CHANGE ORDER – COMMISSION

To:	Glenn Marcos, CPPO, CPPB, FCPM, FCPA, Chief Procurement Officer
From:	David Lovern, Project Manager
Date:	July 2, 2024
Re:	Change Order No. 16 for Project #12573

Job Description:	Project P12573, Project Fort Lauderdale Police Headquarters
Contractor:	Moss & Associates, LLC
Amount:	Total amount of Change Order # $1,634,999.49, plus 0 additional days
Funding:	P12573

SHEET TITLE
PARKING GARAGE - FLOOR PLAN LEVEL 3 - OVERALL
SHEET NUMBER
PG-A2-2-03
©2016 AECOM Corporation
PLANS ARE EXEMPT FROM PUBLIC DISCLOSURE PURSUANT TO F.S. 119.071(3)(b)1

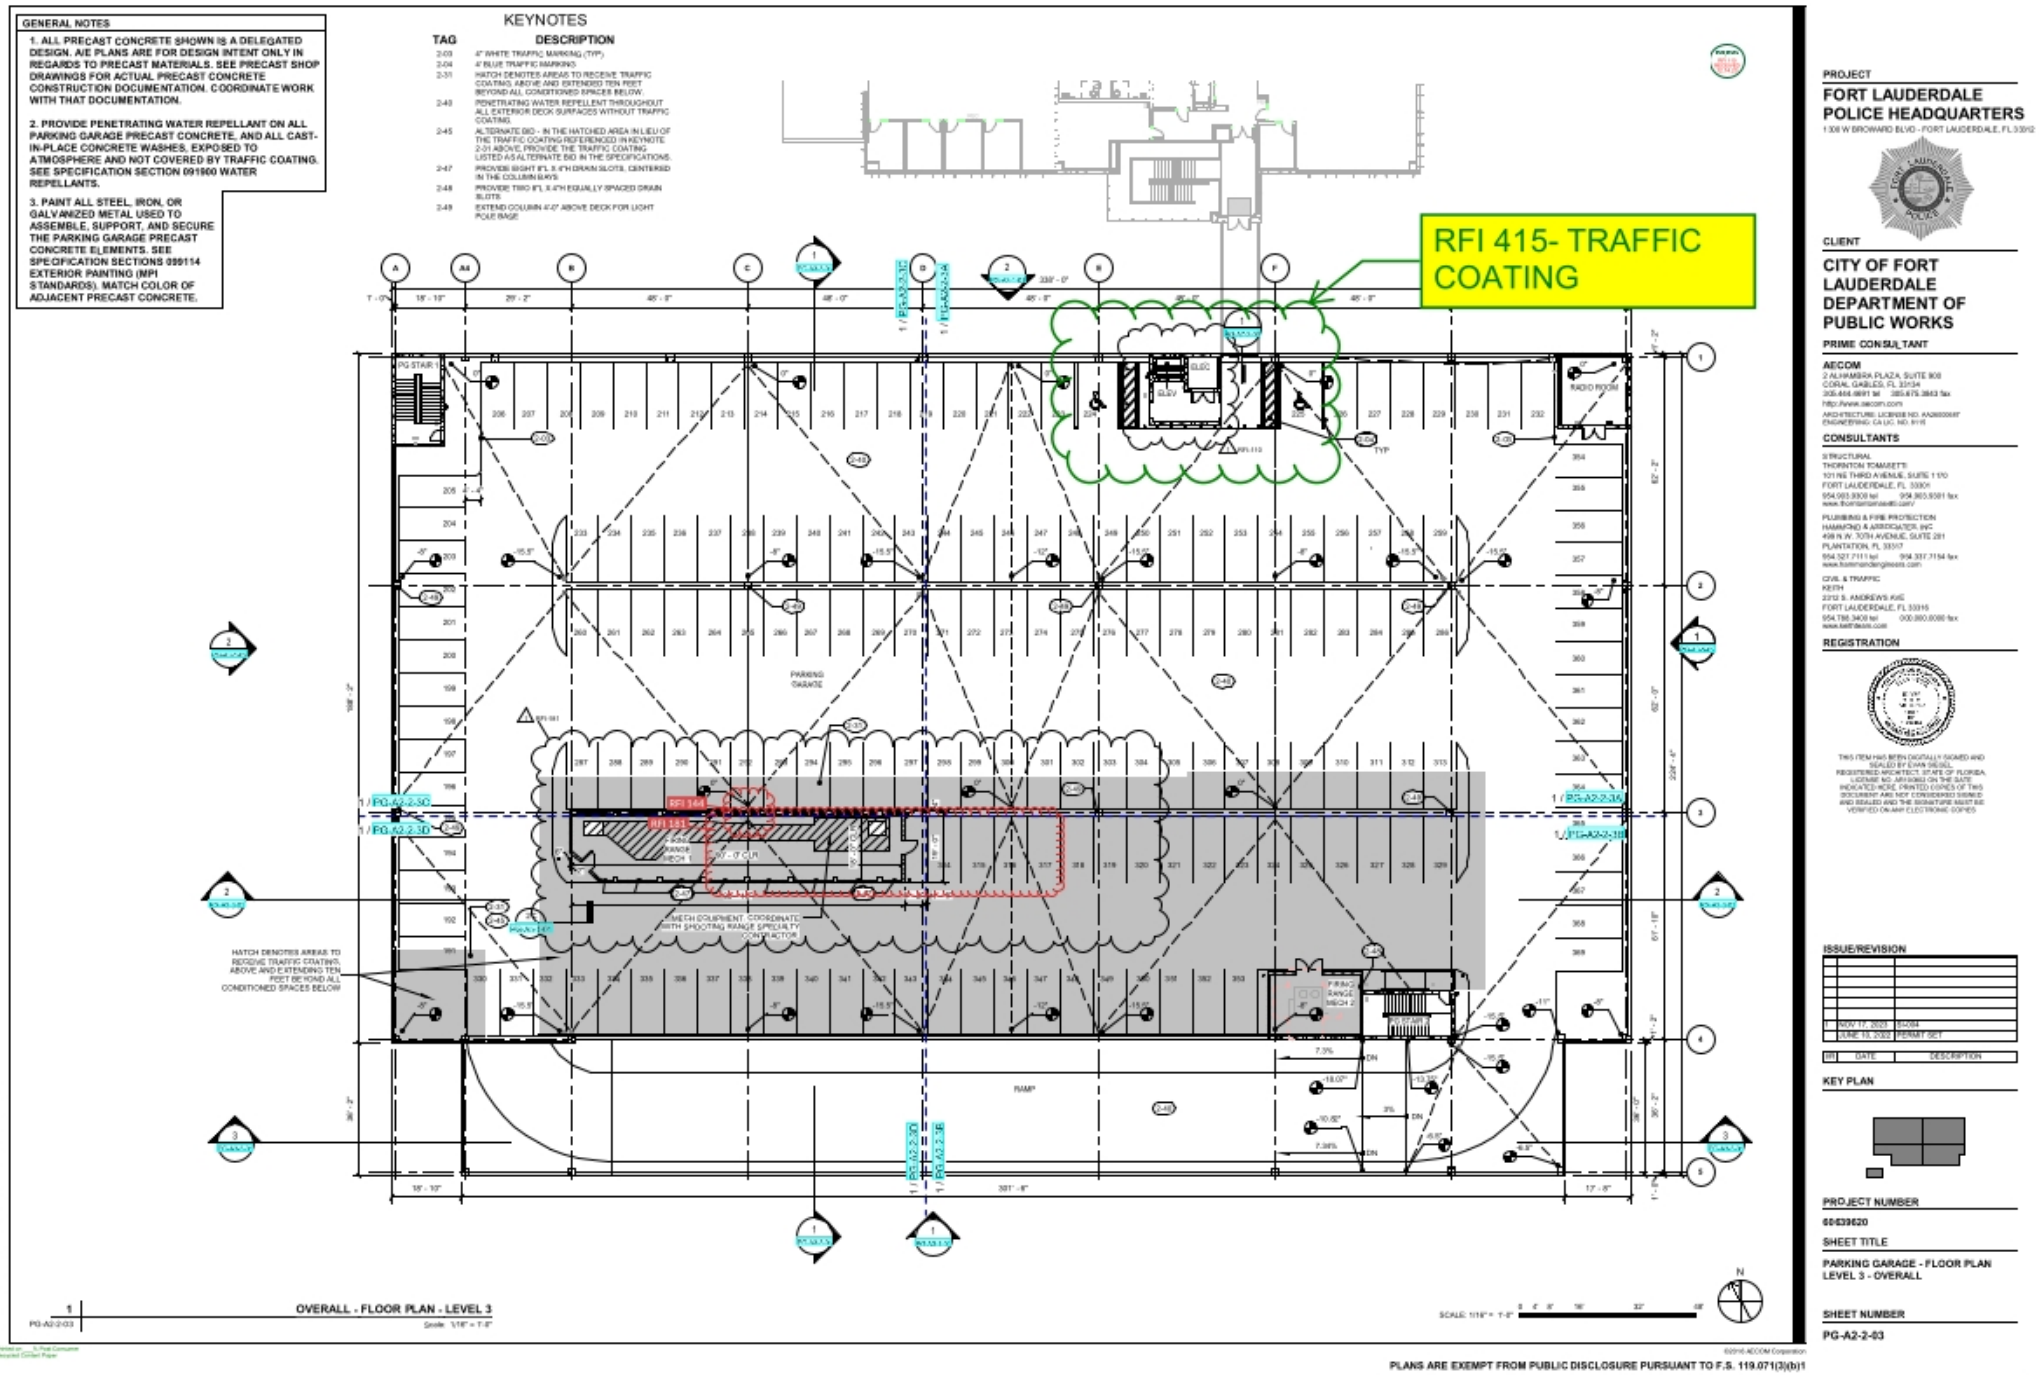
Please take note of the information provided in the attached Drawing PG-A2-2-03. The drawing does not specify a detail of whether traffic coating waterproofing should be applied in the areas where the elevator and electrical room are located, and where these are enclosed by precast panels. Kindly review and advise if traffic coating waterproofing is required in these areas due to the enclosed area.

Per the current design, this area (clouded in RFI) does not require traffic coating.

However, during our most recent site visit and discussion with the client, please provide an estimate for applying traffic coating to the entire 3th level of the parking garage per the base bid (3 coats) in the specification & the alternate bid (2 coats). The area shaded in gray (see page 2) shall remain per the base bid.

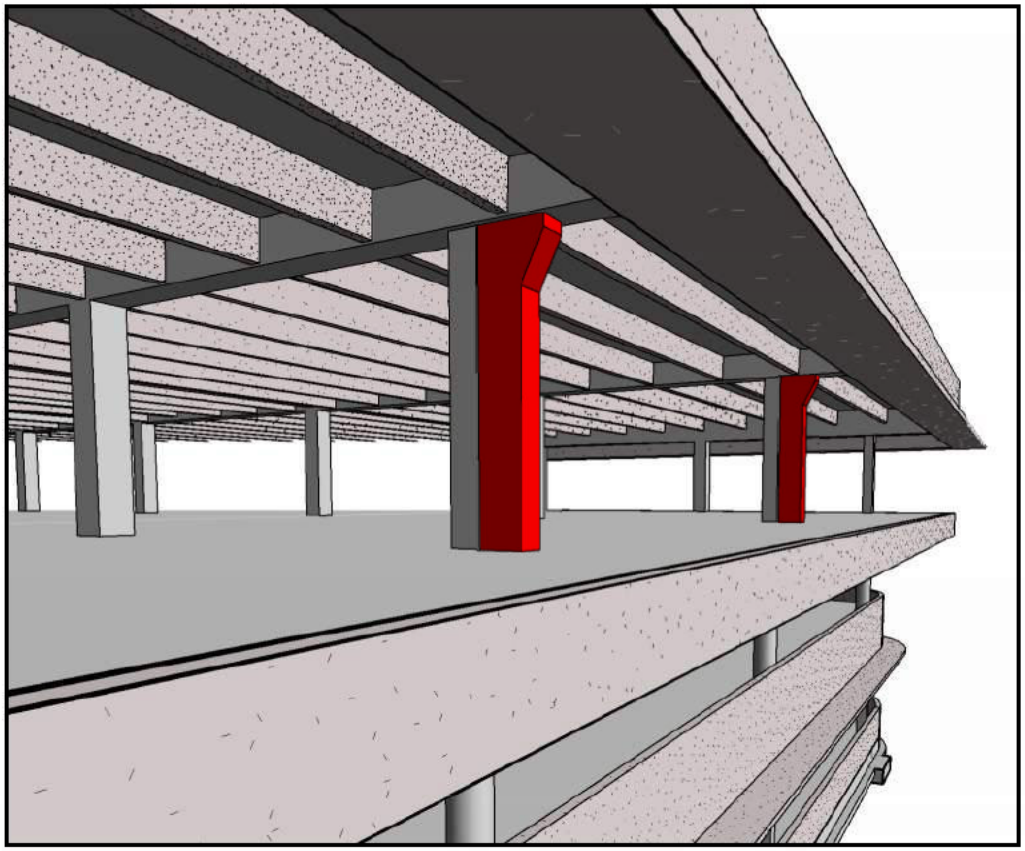
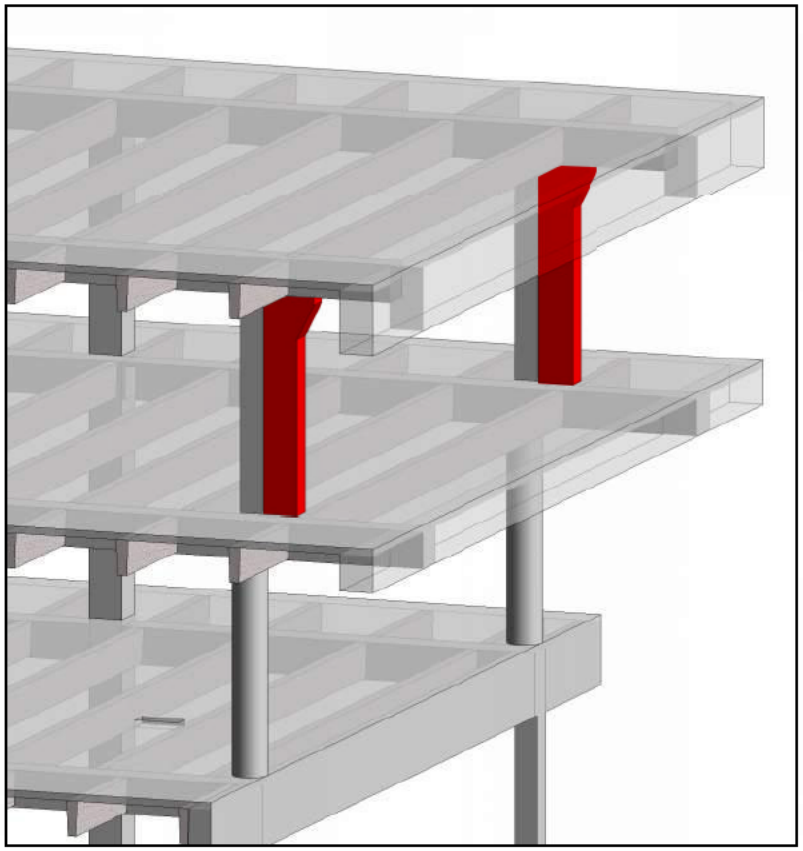
The cross sectional area of the top longitudinal reinforcing steel in beams RSB-76 and RSB-79 is too low. The Code requires a factor of safety of 1.55 for bending behavior in these beams. These beams currently have a factor of safety of 1.15 for bending behavior. This shows the beams are strong enough to support the current load, but the Code requires a better capacity-to-demand ratio for the completed, occupied building. It is worth noting that RSB-76 and RSB-79 are adequately reinforced for their shear demand. We checked all of the other cantilevers (RSB-73, RSB-82, 3SB-87, 3SB-90, 3SB-93, 3SB-96) in the building, and they all have the required reinforcing for their demand.

For RSB-76 and RSB-79, we can get the bending factor of safety up to the 1.55 requirement by reducing the cantilever length. We shall do this by increasing the size of the 3rd floor columns at H-2 and K-2 (see snapshots on the following page).

We have provided SSK-037 and SSK-038 at the end of this PDF, showing the the detailing at the bump-out of these two columns on the third floor. In addition, the spread footings at H-2 and J-2 require strengthening. Refer to new sheet HQ-S6-1-04, included herewith, for the description and detailing of the foundation strengthening. The foundation strengthening does not require any underpinning or shoring.

Note that the cracks do not require repair. As well, the precast panels do not need to be removed. They may be set to to their final position at any time before, during, or after the introduction of column size increase.
